**Planning Commission
Staff Report**
January 18, 2017

Case No:	15ZONE1045
Request:	Change in zoning from R-4 to C-1 on approximately 0.99 acres with variances and a waiver
Project Name:	Outer Loop Restaurant/Retail
Location:	5103 Outer Loop
Owner:	DFWM Outer Loop LLC
Applicant:	DFWM Outer Loop LLC
Representative:	Blomquist Design Group LLC
Jurisdiction:	Louisville Metro
Council District:	24 – Madonna Flood
Case Manager:	Julia Williams, AICP, Planning Supervisor

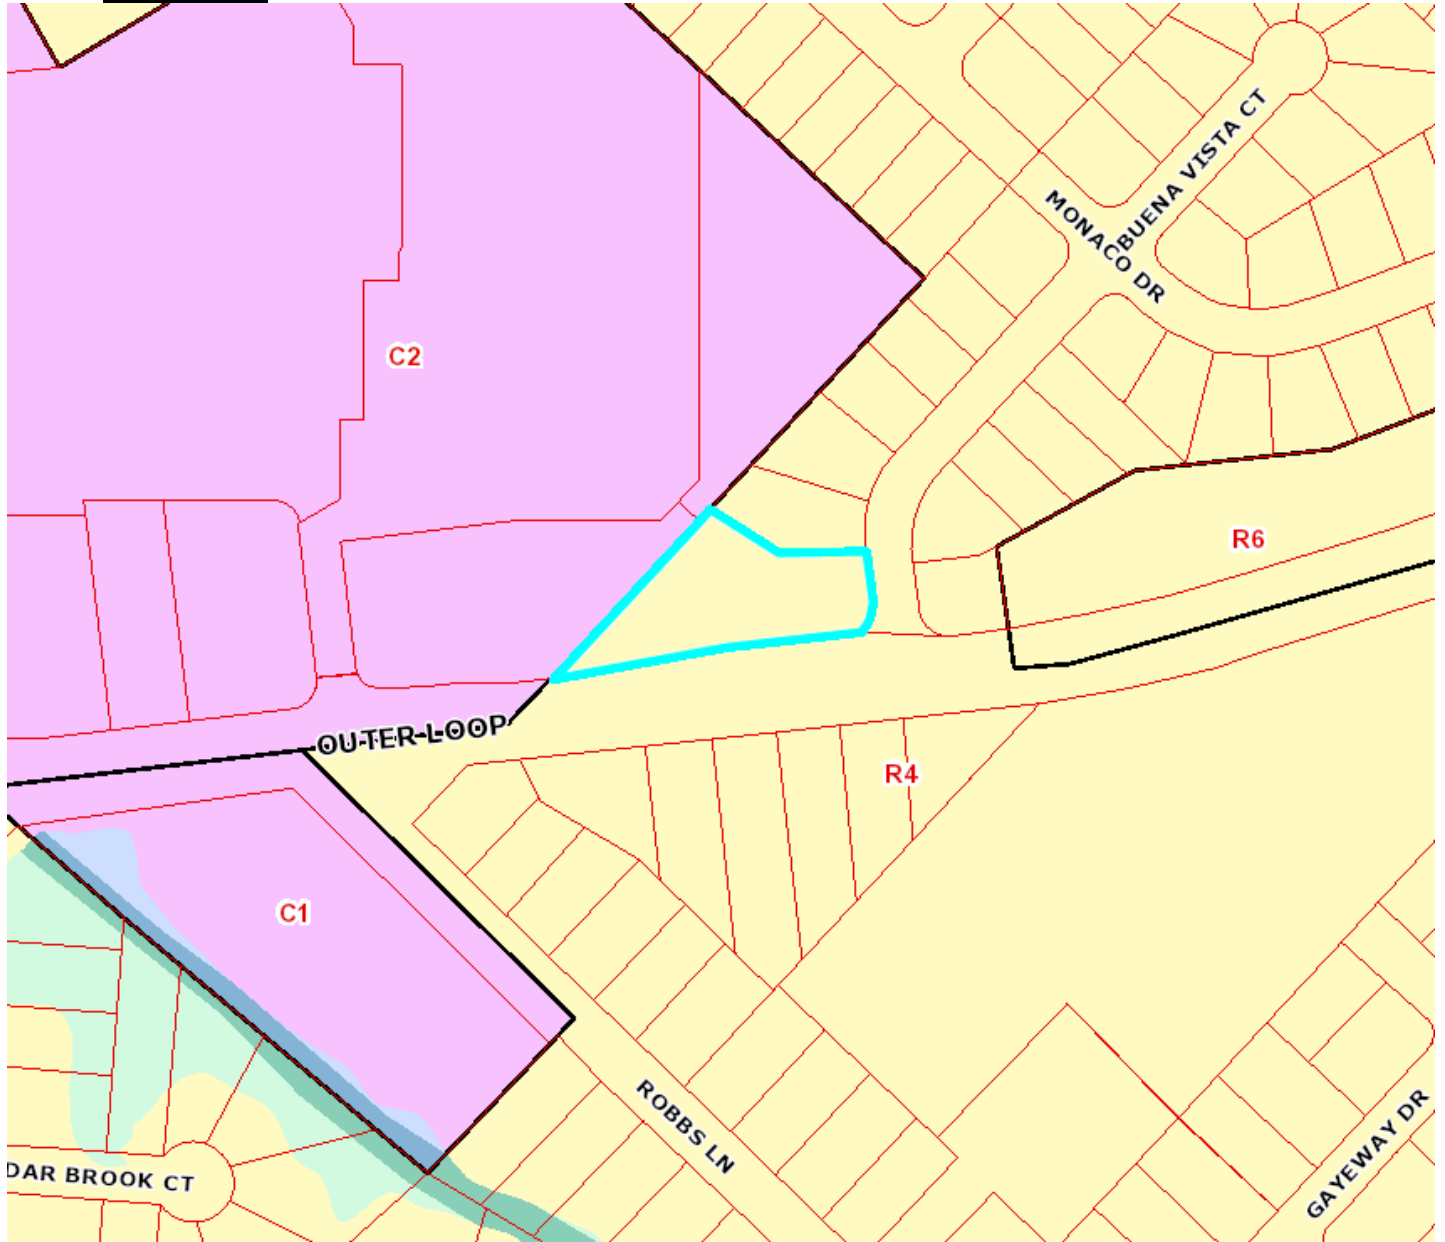
STAFF: Provisions for vehicular and pedestrian transportation within and around the development and the community has been provided and Transportation Planning has no issues with the proposal, however the proposed right in/right out entrance/exit would cause traffic to enter the residential neighborhood and turn around to enter the subject site instead of providing direct access which causes an unnecessary safety issue for people who live in the neighborhood. The access along Buena Vista also does not allow for patrons from within the neighborhood to directly access their neighborhood after visiting the site which is not an efficient traffic movement because it causes the driver to have to make two lefts to get back into their neighborhood.

The applicant should seek the less intense CN zoning for the site as it is more neighborhood serving and would prevent any drive through restaurants from being located on the site which could be a noise nuisance to the adjoining residential property.
